City of Richmond
Urban Development Division

General Compliance Request

Re: **Application by Morrison Hershfield Limited for a General Compliance Request at 5860 Dover Crescent**

That the proposed changes be considered in General Compliance with the approved Development Permit (DP 94-000242) drawings for 5860 Dover Crescent, which cover the following changes:

TYPICAL CANOPY

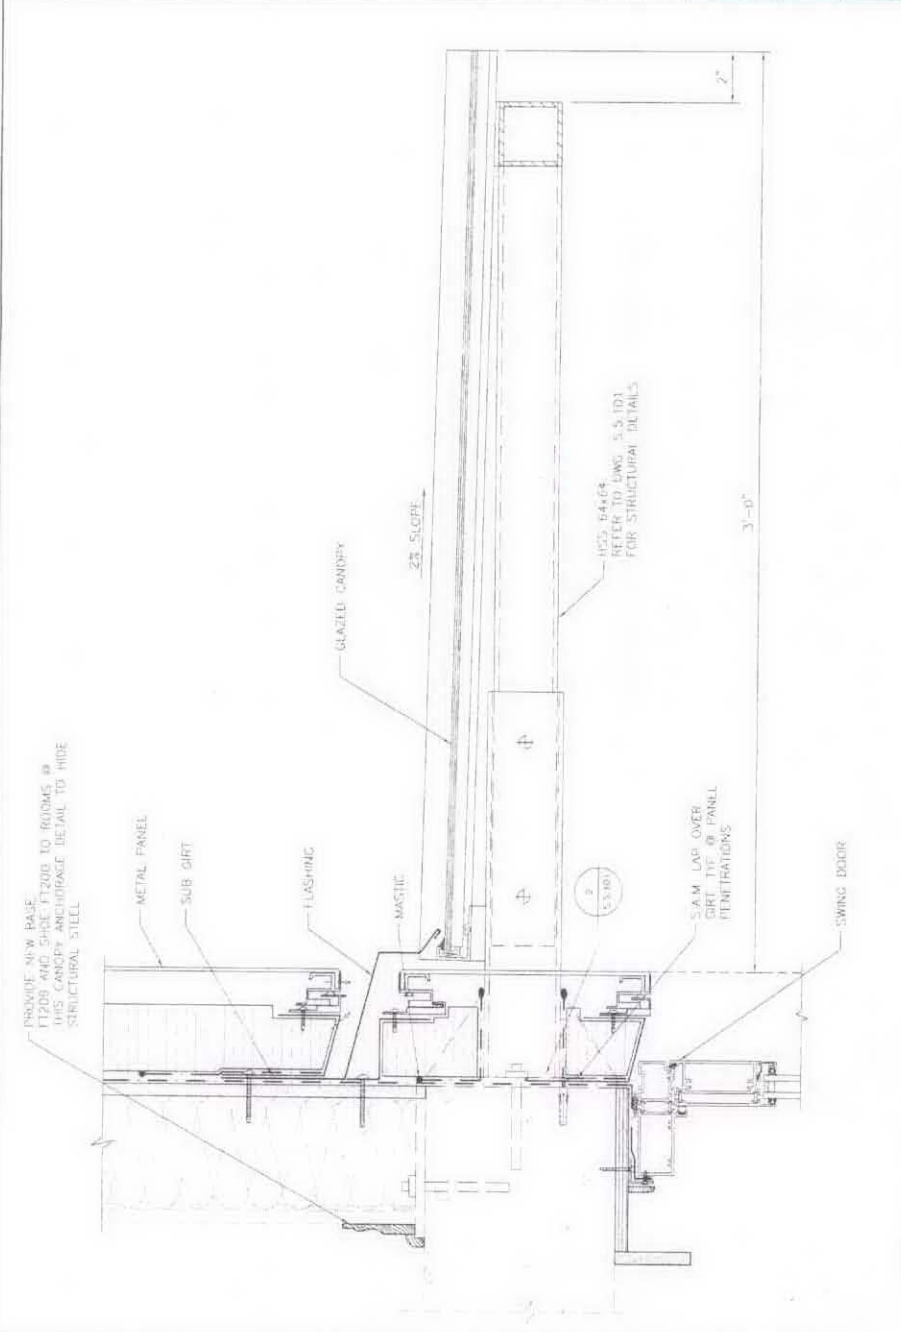
Small glazed canopies (projecting 3 ft) will be installed throughout the building at all exposed external doors and are designed to fit seamlessly into the new proposed cladding. The use of metal support frames and glazing for the canopies is supported considering the extensive use of glazing in the aluminium frames for balcony/deck railings and expanse of windows throughout the building. A detail and cross section of the proposed canopy is shown in the attached drawings.

EXISTING DEVELOPMENT DRAWINGS

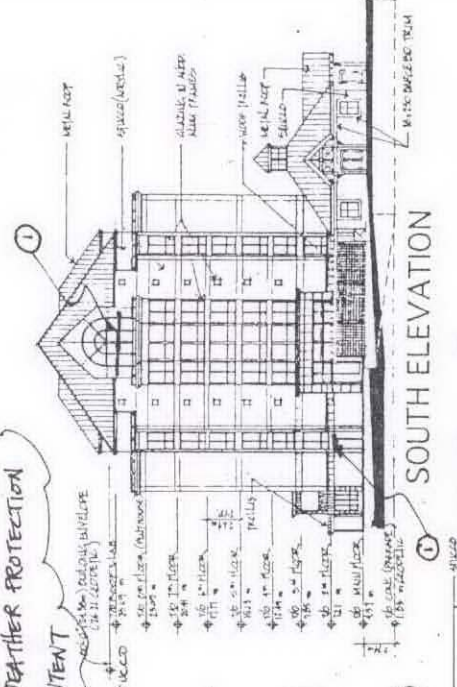
- 1 NEW CANDIES OVER EXPOSED ROOFS FOR WEATHER PROTECTION
- 2 NEW CORNICES TO MATCH EXISTING DESIGN INTENT
- 3 NEW METAL BANISTERING TO REPLACE EXISTING ACRYLIC STICKED
